**3 of 6**

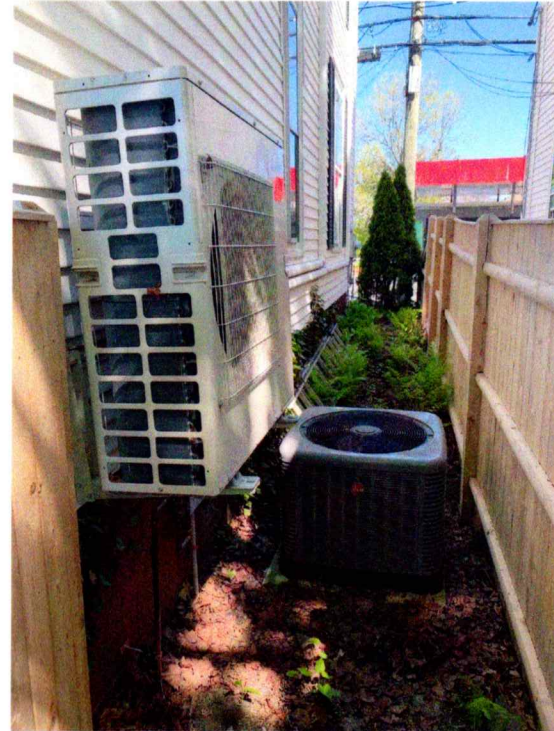
Replace Exist. Storm Windows with Harvey Triple Track Aluminum Storm Windows  
Remove Vinyl Siding & Replace with Cedar Preprimed Beveled Siding & 5/4 x 5 Corner Bds. (CB)  
Repair and or Replace Existing Trim in kind. Remove Shutters.

No change to Attic Window

Remove Lattice Enclosure &  
Remove Heat Pumps & Piping

Replace Existing Storm Windows 1st & 2nd Floor with Harvey Triple Track Aluminum Storm Windows.

Remove Vinyl Siding & Replace with Cedar Preprimed Beveled Siding & 5/4 x 5 CB.

Remove Vinyl Siding & Replace with Cedar Preprimed Beveled Siding & 5/4 x 5 CB.  
Repair and or Replace Existing Trim in kind.

Porch Roof & supporting Beam to be retrimmed with Flat Fascia & Rake.  
Trim Decorative Rafter and Beam tails  
and new Asphalt Roof to match Existing.  
See Attached Sketch 5 of 6.

Existing Basement Windows to remain.

### Left Side Elevation

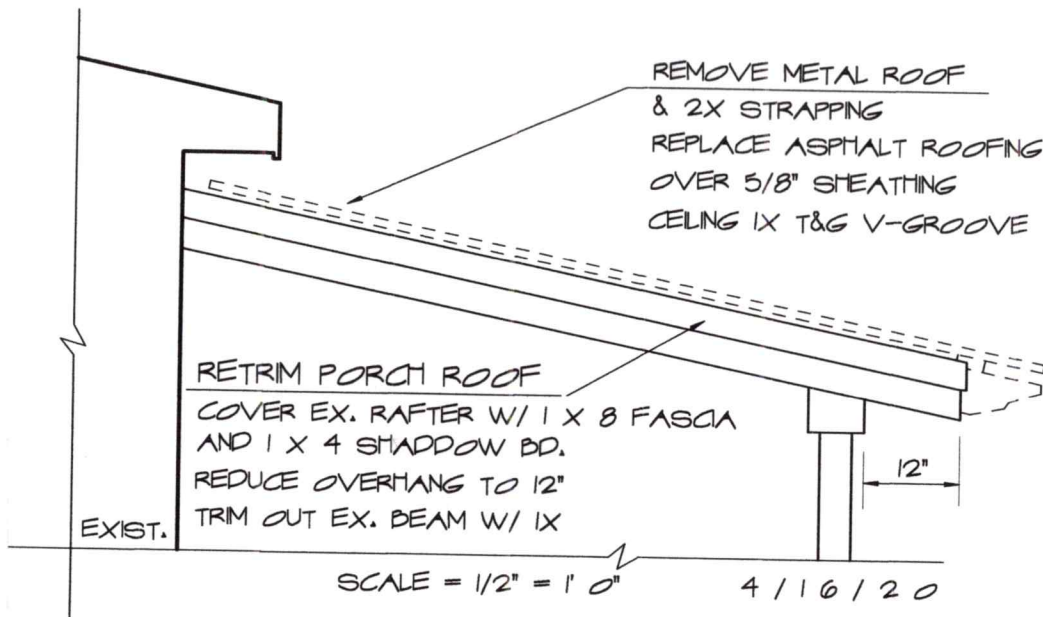
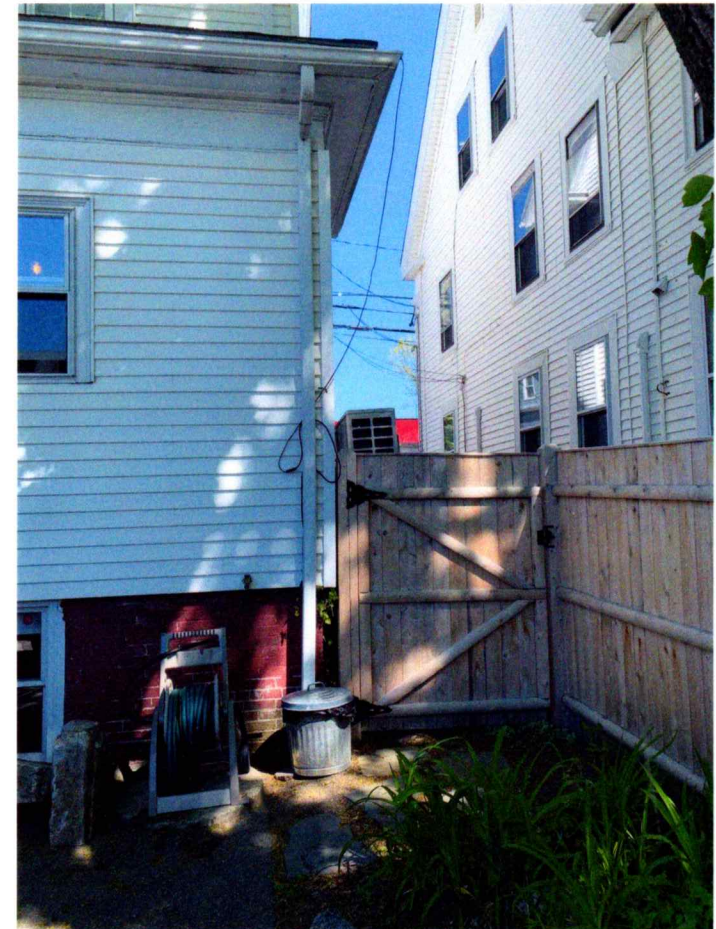
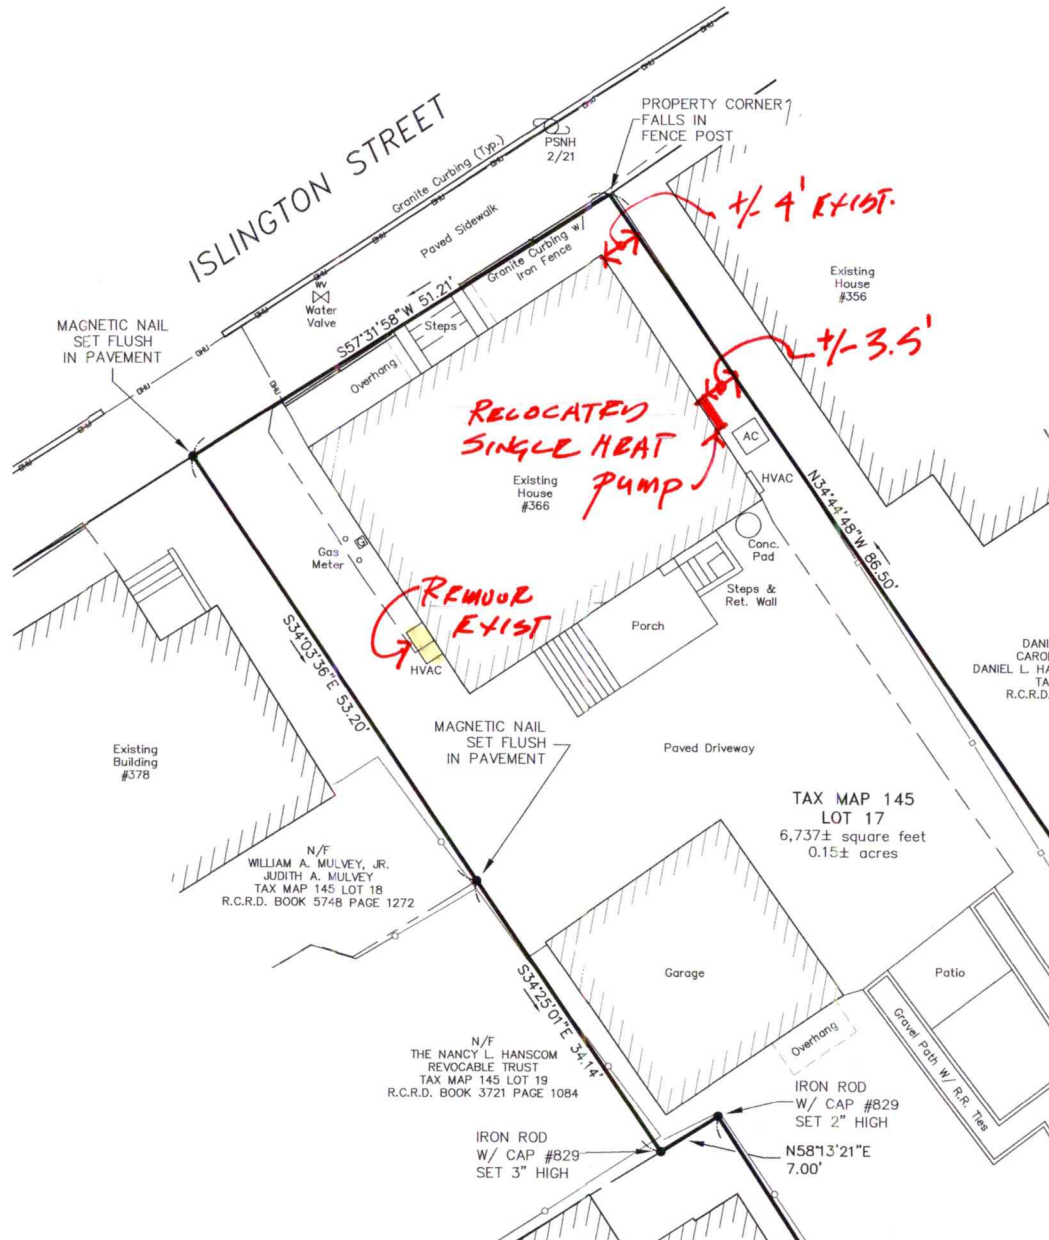
No change to Attic Window

Lower Exist Heat Pump & Add single Heat Pump, relocated from Right Side. The 2 Exist Units on the Right Side will be replaced with 1 Unit. Both will be ground mounted. Exist AC Condensor to remain. See page 6 of 6.

Replace Existing Storm Windows with Harvey Triple Track Aluminum Storms.

Remove Vinyl Siding & Replace with Cedar Preprimed Beveled Siding & 5/4 x 5 CB.

Repair and or Replace Existing Trim in kind. Remove Shutters.
